## ADDENDUM NO. ONE (1)

SIGN-IN SHEET for ITB#6- 2016/2017 GCSC SOFTBALL COMPLEX PROJECT

**1 SITE PLAN**  
 A1.00

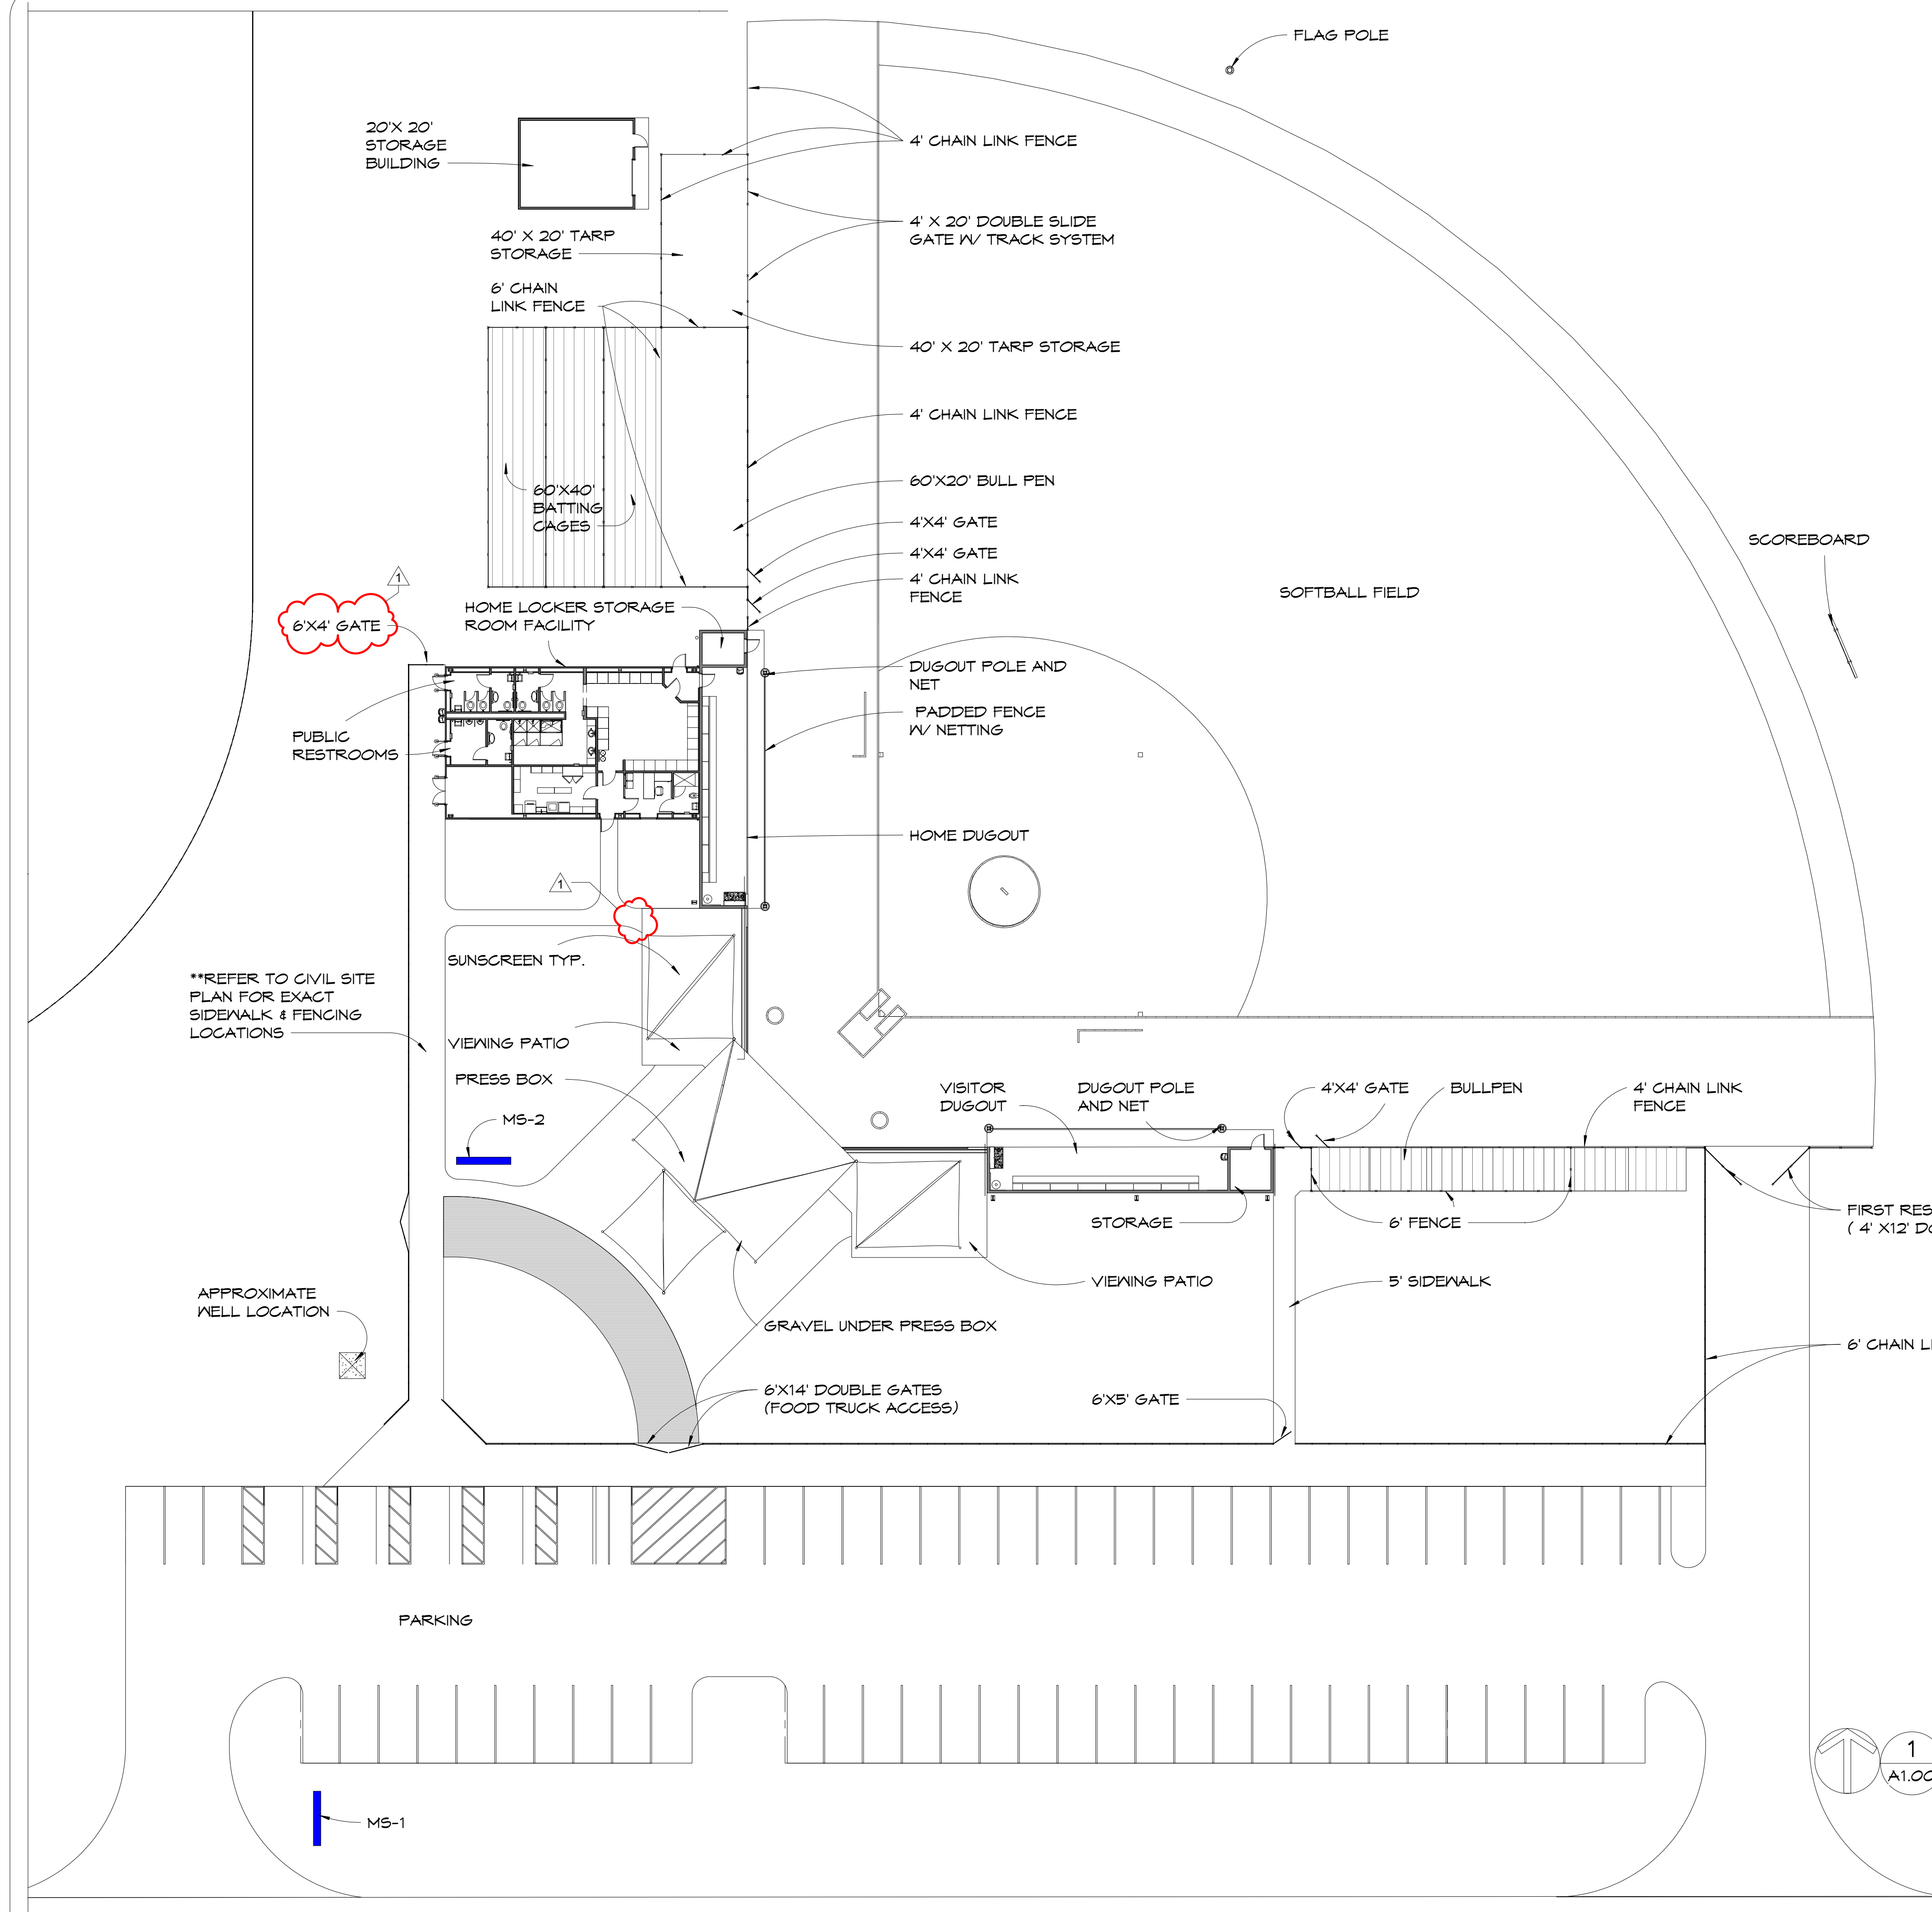
Item No. 2A: Refer to Drawing Sheet A1.00, Site Plan - **DELETE** step adjacent to the Home Dugout. **ADD** the 6'x4' gate to the Adjacent to the Home Locker Room.

SHEET TITLE:  
HOME SIDE LOCKER RM. AND DUGOUT PLAN

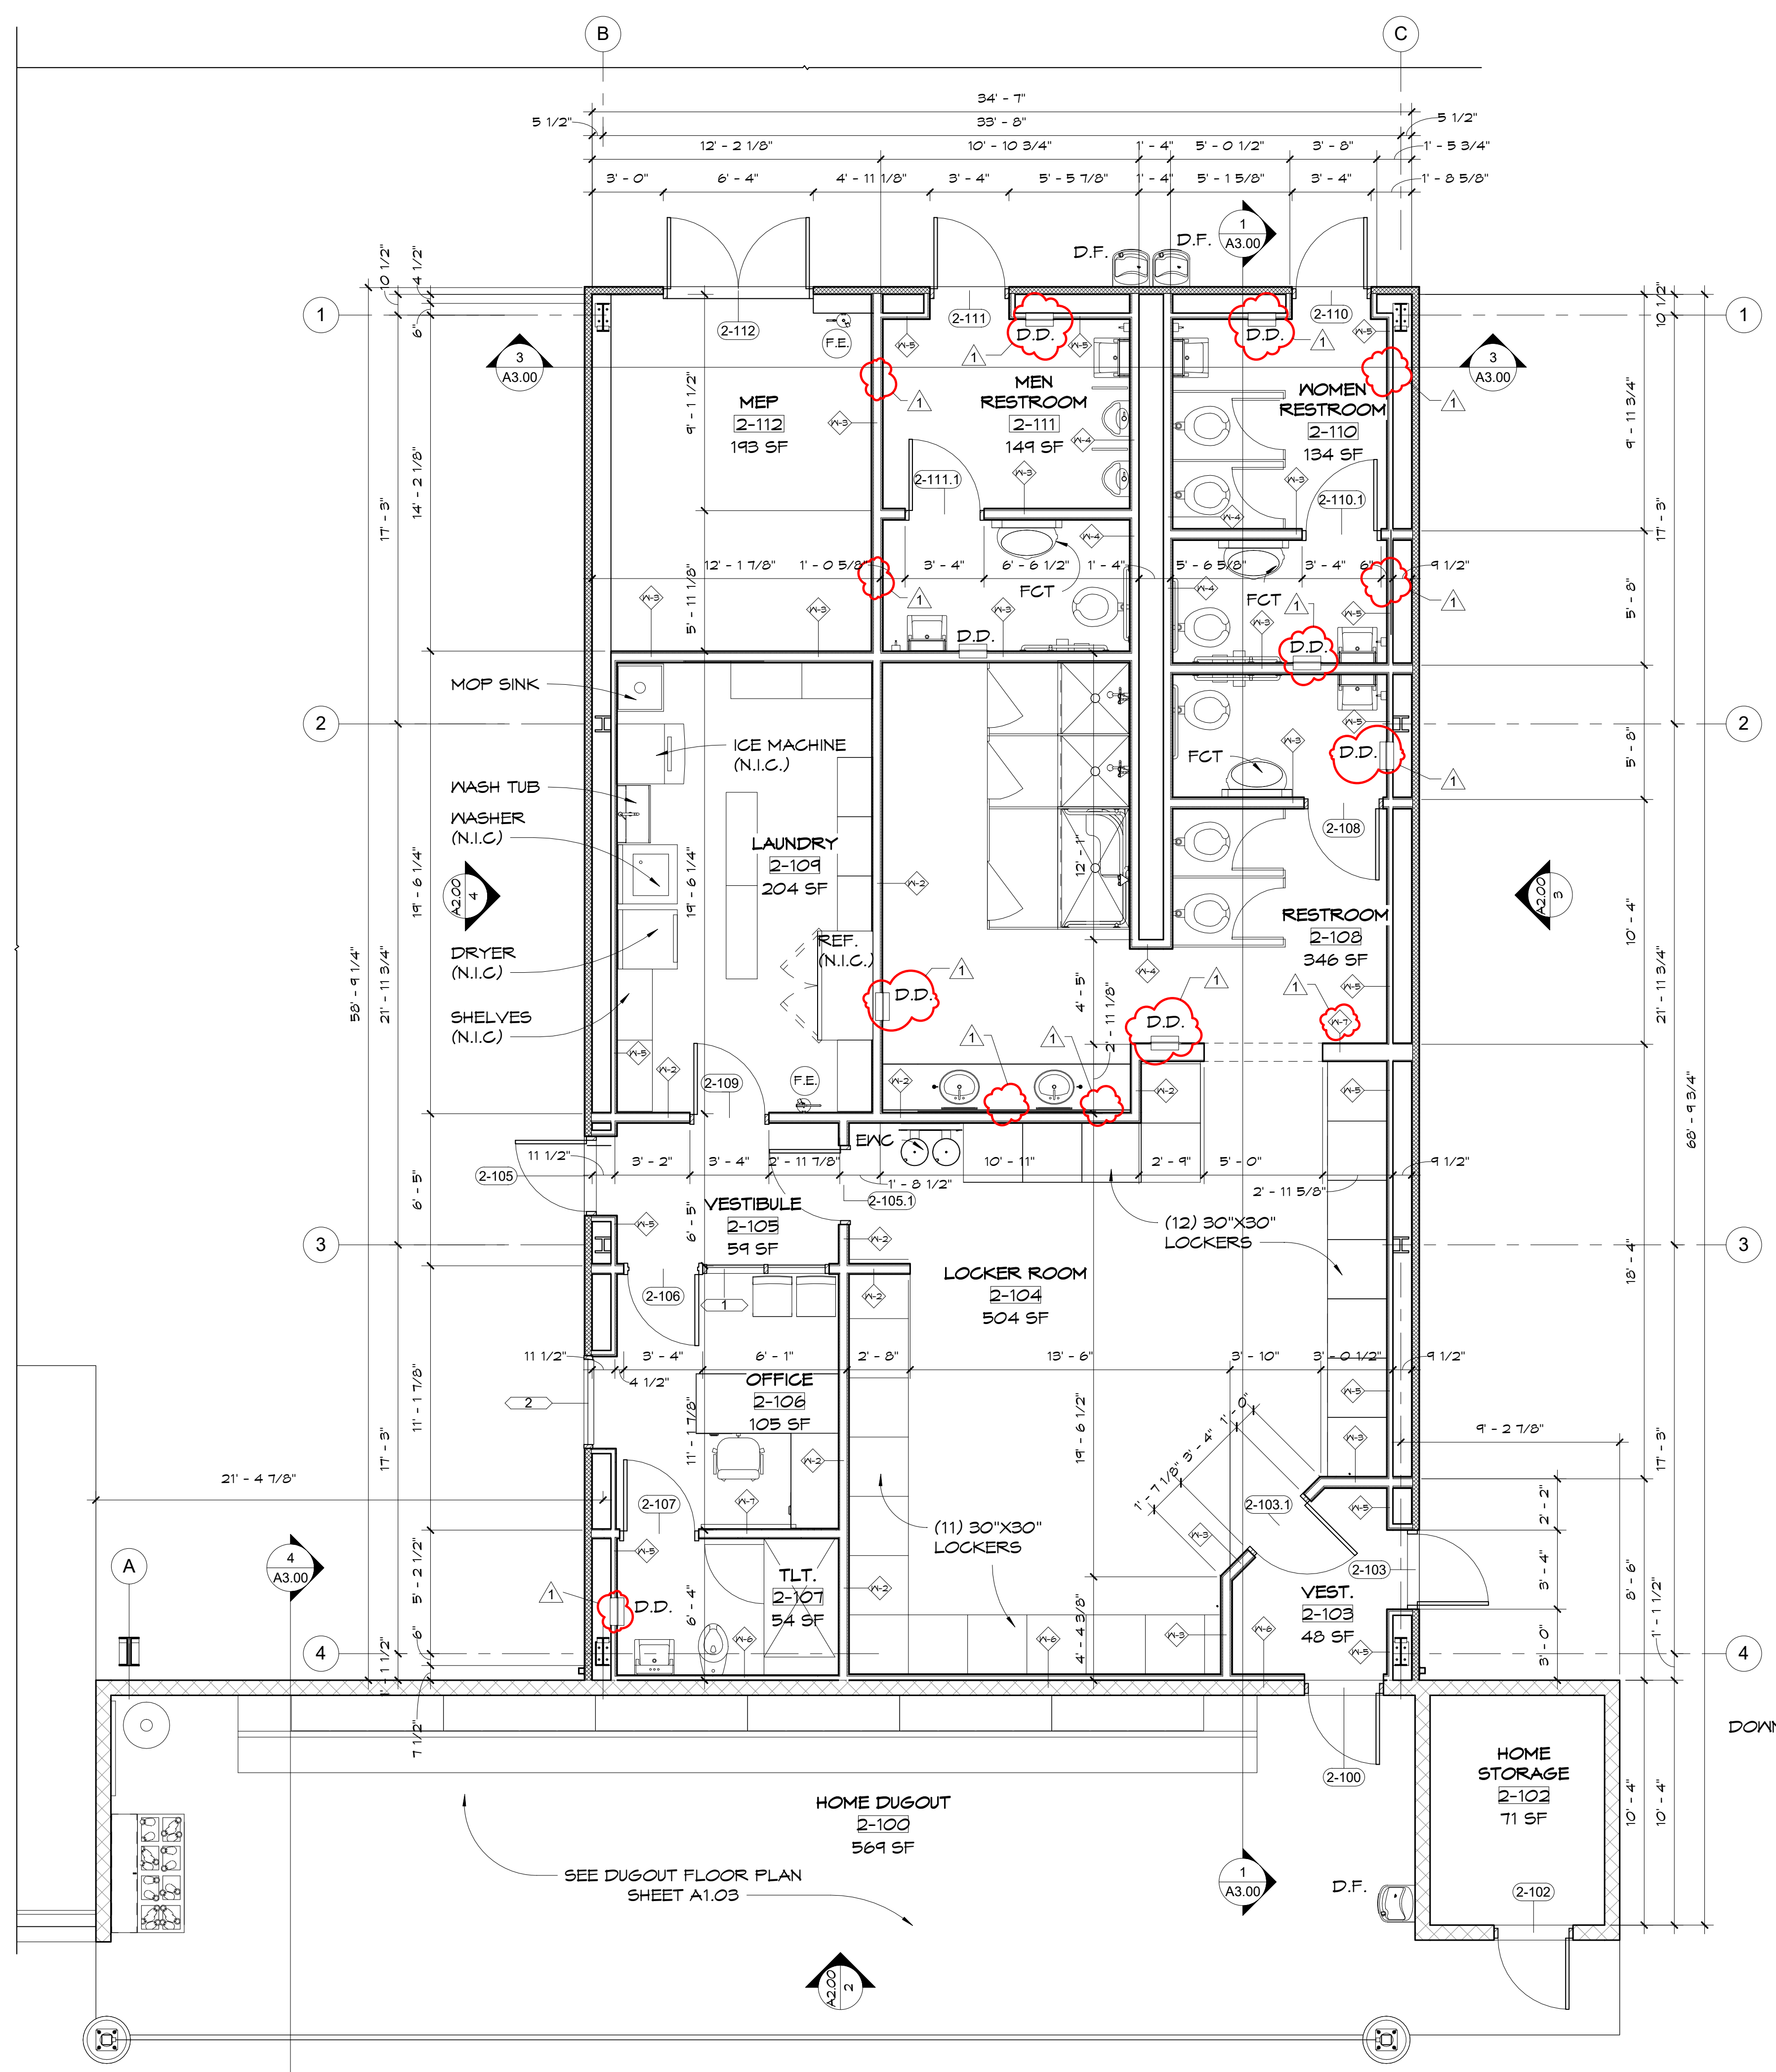
Item No. 4A: Refer to Drawing Sheet A1.04, Home Side Locker Room And Dugout Plan - **CHANGE** General Symbols Legend to reflect a semi recessed paper towel dispenser/disposal (D.D.) **CHANGE** one piece molded countertop length. **DELETE** T.B.'s (Trash Bin) and H.D.'s (Hand Dryers) and **REPLACE** with D.D.'s and notice some new locations.
